RE: S/D 88-73 - Turnpike Industrial Addition. <sup>3rd</sup> Located south  
of 31st Street South, and west of Oliver.

Re: S/D 88-73 - Turnpike Industrial 3rd Addition

CASE NUMBER: S/D 88-73 - TURNPIKE INDUSTRIAL 3RD ADDITION

**STAFF REPORT  
(Preliminary Plat)**

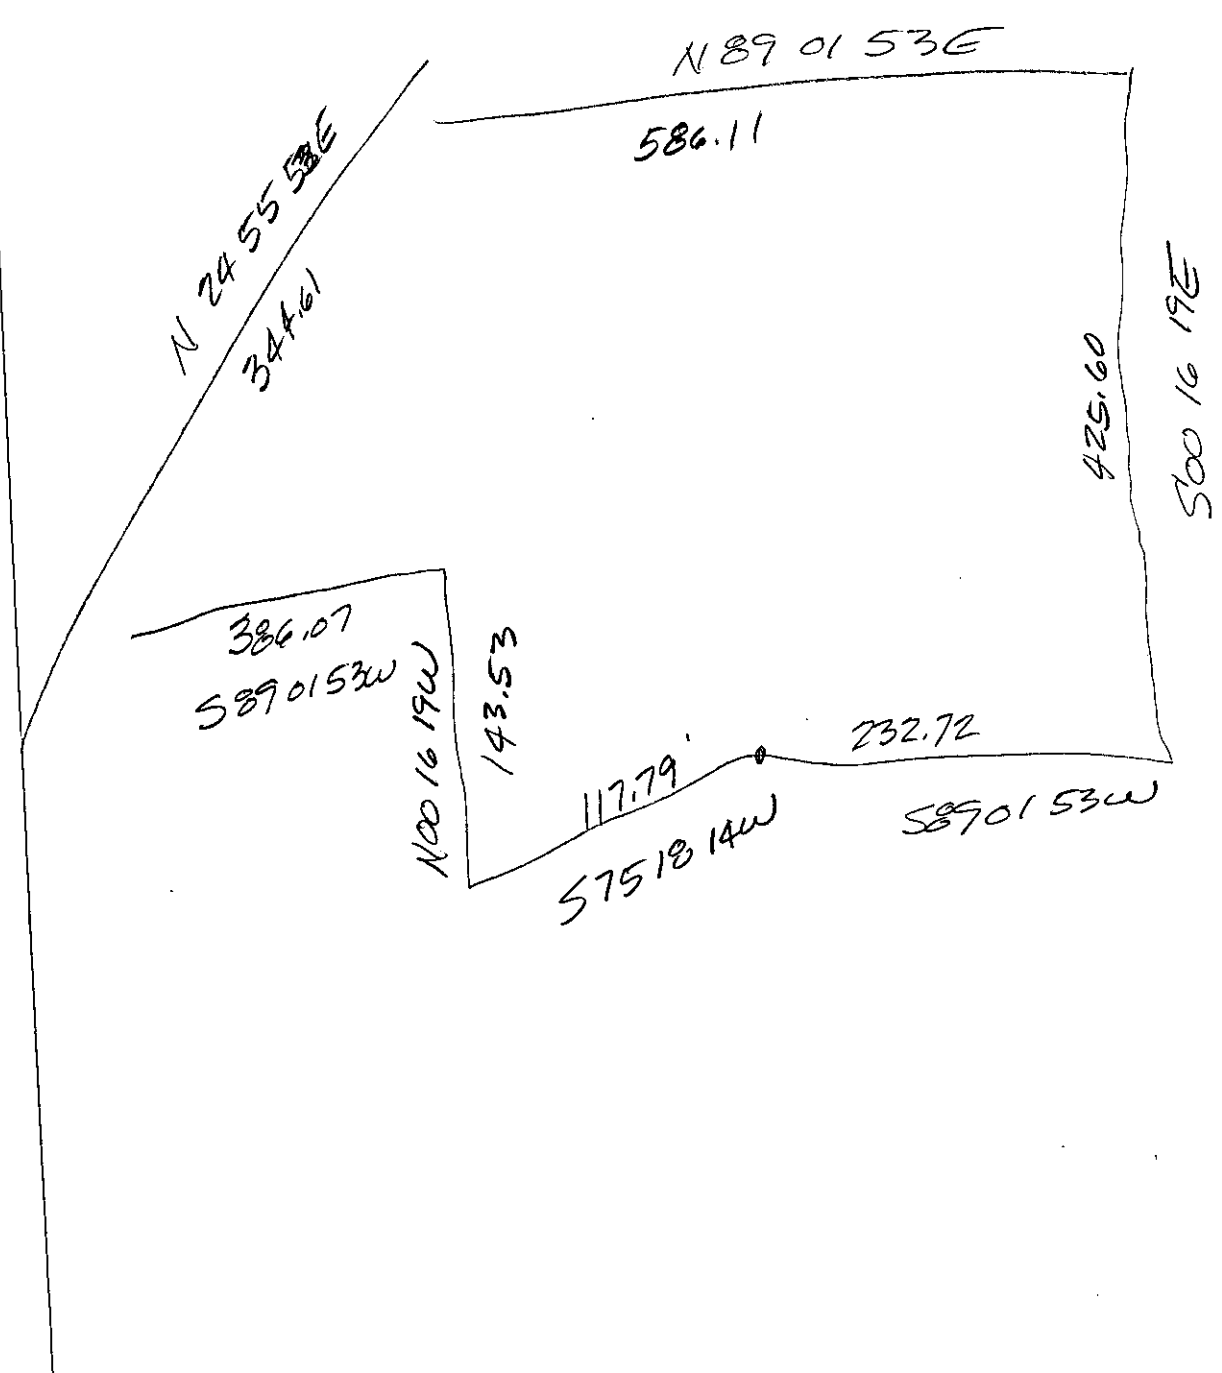
- A. The applicant shall guarantee the extension of municipal water to serve Lots 1 & 2.
- B. The applicant shall guarantee the extension of sanitary sewer to serve Lots 1 & 2.

- C. Drainage improvements may be a part of site development.
- D. The applicant shall guarantee the closure of Colfax Avenue at Oliver. Should the applicant's development plan for this property involve a private driveway at the location of a vacated street return, the applicant is advised that the vacated street return will need to be reconstructed to a private driveway standard. Upon reconstruction to a private driveway, the vacated street approach will be considered closed and the guarantee will be released. If the applicant chooses, he may meet with traffic engineering to determine if a satisfactory alternate can be arranged for the closure of this street. If an alternate is accepted, before scheduling this plat for City Council review, the applicant shall provide a memo for the file indicating that such arrangements have been made.

- E. The applicant shall abandon the existing petition on file for Colfax Circle.

- F. The applicant shall guarantee the paving of Turnpike Drive adjacent to this plat. Prior to filing the final plat tracing, the applicant shall meet with City Engineering regarding the benefit district for this improvement.

- H. As required during review of the preliminary plat, the applicant shall submit a revised drawing of the preliminary plat to include topography lines for lot 3 as depicted on the preliminary, but also this revised preliminary shall include the area to the northeast now being shown within this final. This print shall be submitted prior to submission of the final plat tracing.

- I. The final plat tracing shall show the recording information for any private easements shown on this plat. This information should be shown for the private drainage easement along the south line of lot 3 and if the sanitary sewer easement on lots 1 and 2 is private, it should be labeled as such with the recording information indicated.

- J. The applicant shall submit an avigational easement and restrictive noise covenant for this property. Section 7-107.
- K. Since street right-of-way is proposed for vacation by this plat, reference to K.S.A. 12-512(b) shall be made in the engineer's text.

- L. As required by the drainage concept for this property, the applicant shall obtain a letter from the Turnpike Authority stating that they are willing to accept drainage from this subdivision.

- M. A copy of the water and sanitary sewer service agreement from Boeing, for Lot 3, shall be submitted for the plat file prior to or when submitting the final plat tracing.

- N. On the final plat tracing, the MAPC's signature block shall be amended to indicate Sue L. Crockett, as MAPC chairman.
- O. on the final plat tracing, the owners' signature block shall have printed below it the name and title of the person authorized to sign for the Boeing Company.
